Proposed Development at  
Parkmore Industrial Estate,  
Robinhood, Co. Dublin

Stage 1 Quality Audit

<b>Document Ref:</b>	P25020-PMCE-XX-XX-RP-QA-3_0001
----------------------	--------------------------------

## Stage 1 Road Safety Audit

#### A.1.1 Tactile Paving Provision

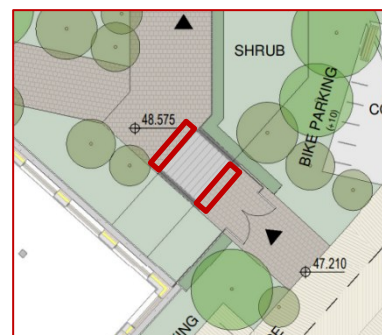
It is proposed to provide shared paths on either side of the Spine Road and along the eastern side of the Robinhood Road. Along the Long Mile Road there appears to be a separate footpath and cycle lane.

However, the transitions between the shared paths and the segregated NMU facilities, as well as between the cycle lane on the Long Mile Road and the shared paths, are not clearly defined at this stage in the design process.

As the design progresses, should insufficient definition at the transitions be proposed, this may result in visually impaired pedestrians being unaware that they have entered an area shared with other road users.

#					Summary of Audit Issue	Design Team Response/Action
1	A.1.1			E.3.6	Tactile Paving Provision	Appropriate edge definition will be provided – in particular by the provision of a 60mm step between the cycle track and the surrounding features. The parking and set down area will be set 70mm-150mm below the general footpath / verge area level in line with urban design standards for kerb heights.
2	A.1.2				Absence of Hazard Tactile Paving at the Steps	Detail of all tactile paving will be added at detailed design stage, to include addressing all requirements of Part M and the Guidance on the Use of Tactile Paving.
3	A.1.3				Absence of Ramped Access	Reviewed and signed off by DAC consultant. Residents are able to use the lift between levels within the adjoining amenity space.
4	A.1.4				Unbound Path Surface	Access to the exercise area can be clearly defined with different hard surface finishes and edging that are accessible to all. This will be detailed in the design phase.

Provide clear and distinct surface treatments at the transition points between shared and segregated paths. This can be achieved by using tactile paving and contrasting colours to alert visually impaired pedestrians of the change in surface.

#### A.1.2 Absence of Hazard Tactile Paving at the Steps

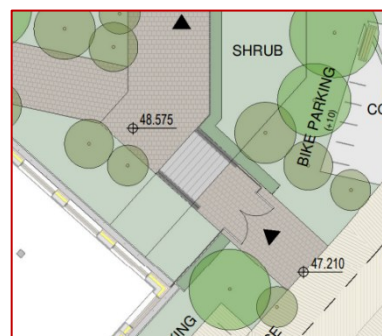
Steps have been indicated adjacent to the Creche. At this stage in the design process, hazard tactile paving has not been indicated at the top and bottom of these steps.

As the design progresses, should hazard tactile paving not be provided at the top/bottom of the steps, this may lead to visually impaired pedestrians being insufficiently aware of steps and not being able to access their destination independently.

Hazard tactile paving should be provided at the top and bottom of steps within the proposed development.

### A.1.4 Unbound Path Surface

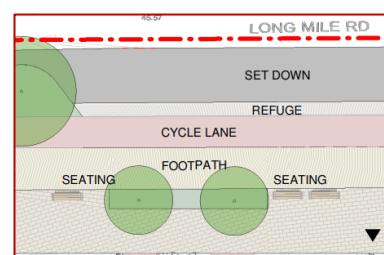
It is proposed to provide unbound “stepping stone” path for the internal footpath to the exercise court adjacent to the Creche.

The proposed stepping stone path could create difficulties for the mobility-impaired and wheelchair users, who would be unable to access the exercise court.

A path with a surface capable of being traversed by all users should be provided at this location.

### A.1.5 Travelling between Set Down Area and Footpath

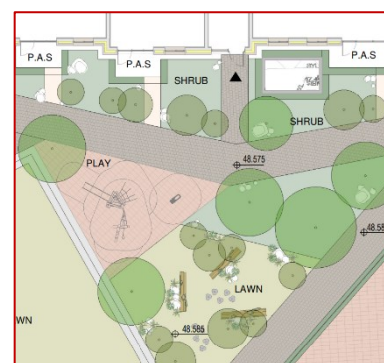
It is unclear from the drawings provided if there will be a level difference between the footpath, cycle lane, pedestrian refuge strip and set-down area along Long Mile Road.

The absence of vertical separation could lead to pedestrians entering the cycle lane or cyclists entering the footpath, increasing the risk of conflicts between these road users.

Should a kerb be provided between the set-down area and the pedestrian refuge strip, and between the refuge and the cycle lane, there may be difficulties for mobility-impaired vehicle occupants traveling to/from the footpath and the set-down areas.

5	A.1.5			E.3.8	Travelling between Set Down Area and Footpath	It had not been intended to provide a specific mobility impaired parking space within the parking / set down area, but appropriate provision for these users will be agreed with the Local Authority and appropriate crossings will be added at detailed design stage to suit. Mobility impaired parking is provided for within the underground car park, with full accessibility to the upper levels provided via lifts.
6	A.1.6				Absence of Seating	Seats can be added in detailed design; however, there is an informal play and seating area with wooden logs nearby, providing a natural feel.

Ensure appropriate kerb heights are provided between the footpath, cycle lane, pedestrian refuge strip and set-down areas. In addition, crossing points between the footpath and set-down areas should be provided capable of being traversed by all users safely.

### A.1.7 Details of Benches

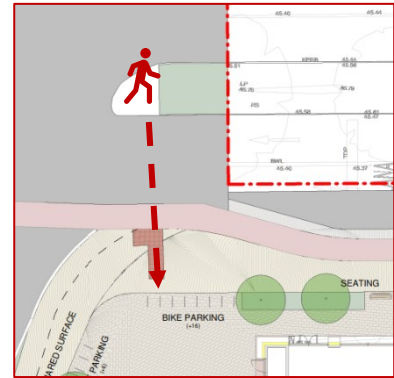
Timber benches are indicated across the proposed development. It is, however, unclear if the proposed benches will be accessible to a wide variety of users. Benches whose bases are narrower than the rest of the bench can create difficulties for long-cane users in detecting and avoiding colliding with the bench.

#					Summary of Audit Issue	Design Team Response/Action
7	A.1.7				Details of Benches	Refer to L1-804 and the Hard Materials Palette in the design statement, which indicate a bench with a solid stand and backrest. An armrest can be added and will be detailed in the final design.
8	A.1.8				Bicycle Stands along the Pedestrian Route	For the bike stands on Long Mile Road, they can be placed on different hard surface finishes with proper edging to ensure they do not pose an issue for visually impaired users.
9			C.1.3	E.3.13	No formal pedestrian crossing has been indicated on the Spined Road at its junction with the Long Mile Road between the development and the bus stops to the east.	This is intended to be a pedestrian priority crossing, with crossing vehicles yielding to pedestrian
10			C.1.2	E.3.14	Absence of Crossings on Robinhood Road.	It is intended to add a signalised crossing of Robinhood Road in consultation with the Local Authority.

To accommodate the widest possible mix of disabilities a mixture of benches with & without armrests should be provided. The benches should have solid bases and no part of the bench should protrude beyond the extents of the base.

#### C.1.1 Insufficient Width of Crossing at the Robinhood Road/Long Mile Road Junction

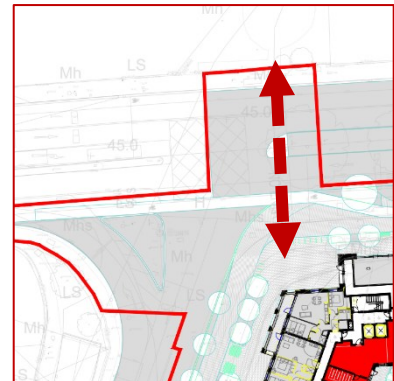
It is proposed to retain the existing signalised crossing on Long Mile Road at its junction with the Robinhood Road, which is currently for pedestrians only, and relatively narrow.

It is likely that this would be too narrow to accommodate the peak volumes of pedestrians following construction of the scheme, and would be insufficiently wide to accommodate both pedestrians and cyclists.

A toucan crossing with a minimum width of 4m should be provided at this location.

#### C.1.2 Absence of Crossings on Robinhood Road

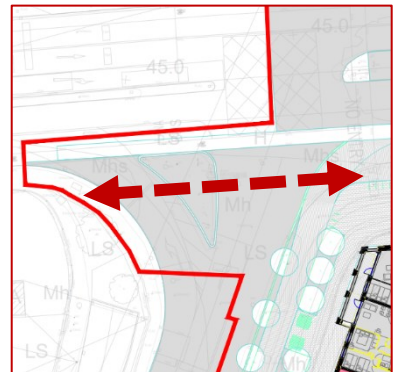
No changes have been indicated to the existing pedestrian crossing arrangements of Robinhood Road at its junction with the Long Mile Road for pedestrians travelling east/west along the southern side of the Long Mile Road.

It is likely that pedestrian desire lines will exist between the proposed development and the neighbouring area(s) to the west. The existing crossing arrangements are uncontrolled crossings, of a relatively wide carriageway, which cannot be used independently by the visually-impaired.

The combination of the expected increased numbers of pedestrians wishing to cross, the length of the crossing and the absence of a controlled crossing could create difficulties for NMU travel to/from the development and the areas to the west.

The need, or otherwise, for improved pedestrian crossing facilities of Robinhood Road, including a possible controlled crossing, should be assessed and provided if required.

### 3.1 Traffic Lane Widths on Long Mile Road

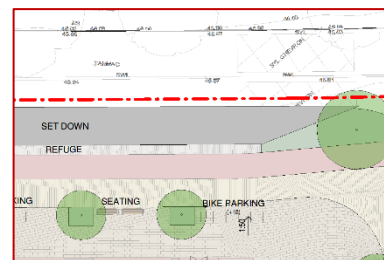
**Location:** General Arrangement Plan – Sheet 1 of 2, L1-100-1 Rev. 03  
General Arrangement Plan – Sheet 2 of 2, L1-100-2 Rev. 03

20				E.3.1	Narrowed section of bus lane on the Long Mile Road may result in buses encroaching into the adjacent traffic lane and possible side-swipe collisions	It is proposed to amend the road markings to maintain a minimum bus lane width of 3m, which is in line with current design standards, and swerve arrows have been added to the layout. It is also noted that BusConnects intends to remove bus services from this section of the Long Mile Road.
21				E.3.2	Should general traffic be expected to turn left onto Robinhood Road from the general traffic lane, this could result in vehicular/cyclist collisions with straight-ahead cyclists within the cycle lane.	That is not proposed. Left turns will be from the bus lane.

The lane configuration on the Long Mile Road should be reviewed to ensure that the amended road layout can safely accommodate the expected volumes & type of vehicles using them, and the likely manoeuvres being undertaken.

### 3.2 Left turns from Long Mile Road onto Robinhood Road

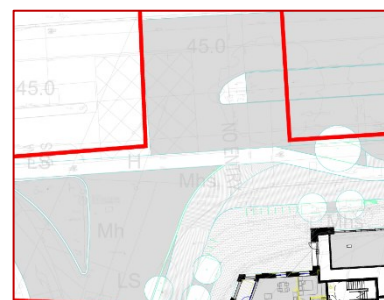
**Summary:** Should general traffic be expected to turn left onto Robinhood Road from the general traffic lane, this could result in vehicular/cyclist collisions with straight-ahead cyclists within the cycle lane.

### 3.4 Exiting Manoeuvres from Set-Down Area Close to Junction

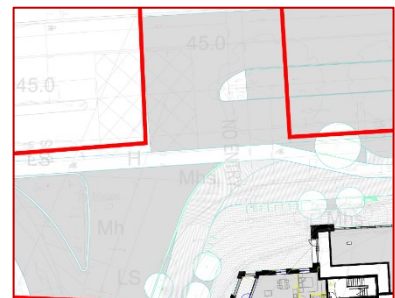
**Summary:** The proximity of the set-down area to the Robinhood Road junction may result in unsafe exiting manoeuvres from the set-down area.

The proposed amended road layout should be reviewed, and if necessary amended, to ensure that drivers exiting the proposed set-down area can do so safely.

### 3.5 Crossing Width

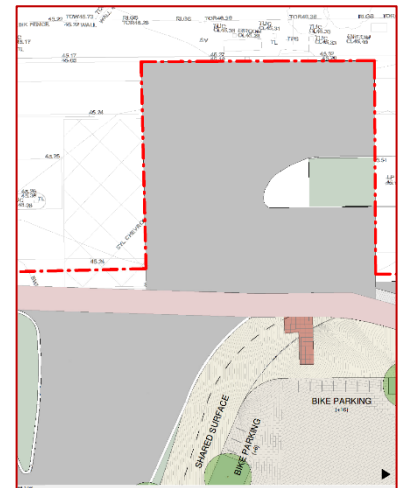
*Location: Long Mile Road*

The existing signalised pedestrian crossing should be amended to be a Toucan crossing, including pedestrian and cyclist signal heads and push button units and should be a minimum of 4m wide.

### 3.6 Transitions between Shared and Segregated Paths

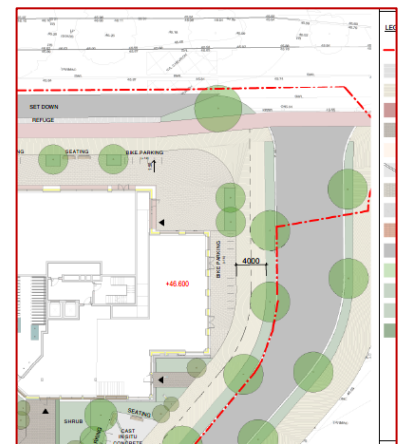
It is proposed to provide shared paths internally within the proposed development, on either side of the Spine Road and along the eastern side of Robinhood Road, and to provide a segregated footpath and cycle lane along Long Mile Road.

During the design development ensure that appropriate measures provided at the transitions between shared and segregated paths. This could be achieved by using tactile paving and contrasting colours to alert visually impaired pedestrians of the change in surface.

### 3.8 Set-Down Area Crossings

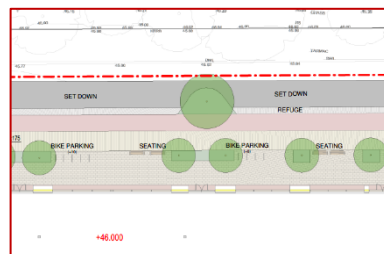
*Summary: Lack of edge definition between footpath, cycle lane, pedestrian refuge strip, and set-down areas could result in*

At this early stage in the design process it is unclear if it is proposed to have a level difference between the footpath, cycle lane, pedestrian refuge strip, and set-down area along Long Mile Road.

### 3.10 Visibility Splays

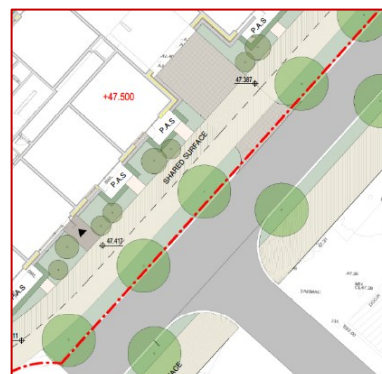
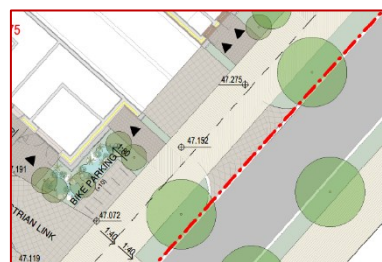
**Summary:** Planting at the access to the underground car parks may impede inter-visibility increasing the risk of vehicle/NMU or side-on collisions.

Planting indicated either side of the at the accesses to the underground car parks. At this early stage in the design process it is unclear exactly what type/species of planting is proposed, and consequently it is unclear if this planting could impede inter-visibility between drivers exiting the car parks and pedestrians/cyclists on the adjacent shared path or with drivers of vehicles on the adjacent carriageway.

25				E.3.10	Planting at the access to the underground car parks may impede inter-visibility increasing the risk of vehicle/NMU or side-on collisions.	Planting will be maintained to ensure that this does not arise.
26				E.3.11	Bin staging area may require refuse vehicle to be driven through the pedestrian link resulting in potential for conflicts.	Refuse vehicle movements will be marshalled by staff within the development.
27				E.3.12	Potential for development traffic wishing to travel eastward, towards the city centre, undertaking unsafe manoeuvres	Access towards the city for a small volume of development traffic will be via the existing turning facility before the "hamburger" junction of the Long Mile Road and the Naas Road.
28				E.3.15	It is unclear if large vehicles will be able to enter/exit the Spine Road without encroaching into the opposing traffic lane.	Autotrack indicates that this is not the case.

### 3.15 Junction Swept Path

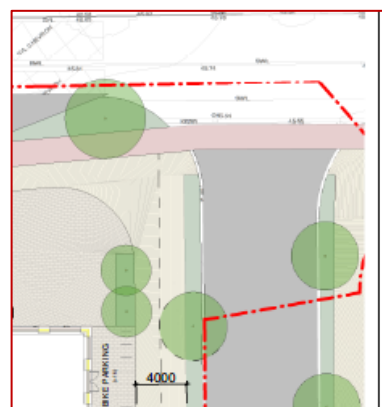
**Summary:** It is unclear if large vehicles will be able to enter/exit the Spine Road without encroaching into the opposing traffic lane.

### 3.16 Parking Spaces Swept Path

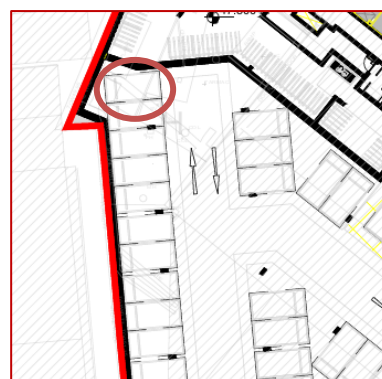
**Summary:** It is unclear if there is sufficient space to safely accommodate the swept path of vehicles entering/exiting some of the parking spaces within the underground car park.

There are a number of locations where it is unclear if there is sufficient space to safely accommodate the swept path of vehicles entering/exiting proposed parking spaces.

29				E.3.16	It is unclear if there is sufficient space to safely accommodate the swept path of vehicles entering/exiting some of the parking spaces within the underground car park.	Access to car parking spaces is confirmed as being possible.

A swept path analysis should be undertaken to ensure sufficient space is available at all proposed car parking spaces, or the layout should be adjusted accordingly.

### 3.17 Car Park Priority

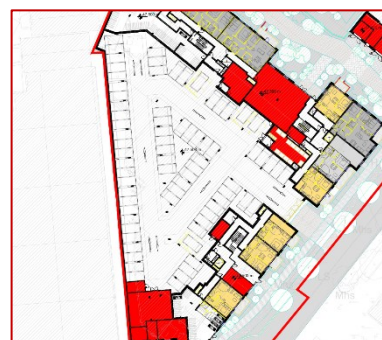
**Summary:** Priority within the car park is unclear.

A combination of one-way and two way travel for vehicles has been indicated within the underground car park. At this early stage in the design process not all signs or roadmarkings have not been indicated within the car park. Should signs/road markings not be included to advise drivers of the correct direction of travel and/or priority where aisles meet, this could result in driver confusion and the potential for two vehicles to proceed simultaneously leading to low-speed side-on collisions.

#					Summary of Audit Issue	Design Team Response/Action
30				E.3.17	Priority within the car park is unclear.	A signage strategy will be developed to confirm priority at detailed design stage.
